HEARING DATE: April 6, 2023

TO: Planning & Zoning Commission

FROM: Stacy Hersh, Associate Planner
208-884-5533

SUBJECT: Crowley Park Subdivision
H-2023-0006

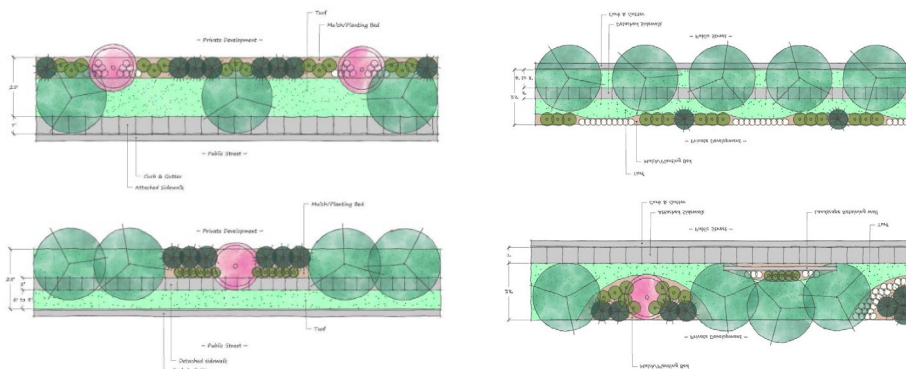
driveway. The Applicant is proposing five (5) dwelling units take access off the common driveway, all five (5) dwelling units are also located on one (1) side of the driveway. *Per UDC 11-6C-3D.9, the Director may approve or recommend approval of alternative design or construction standards when the applicant can demonstrate that the proposed overall design meets or exceeds the intent of the required standards of this section and shall not be detrimental to the public health, safety, and welfare.*

Alternative Compliance (ALT) to the common driveway standards is requested due to the lot only having access from an arterial roadway; there is no local street connection available to this site. Staff recommended this site layout to allow for more usable backyards for the southernmost lots, as the south boundary is encumbered by an irrigation easement. Based on the analysis, the Director is supportive of the request for ALT for the proposed five (5) dwelling units taking access off the west side of the common driveway.
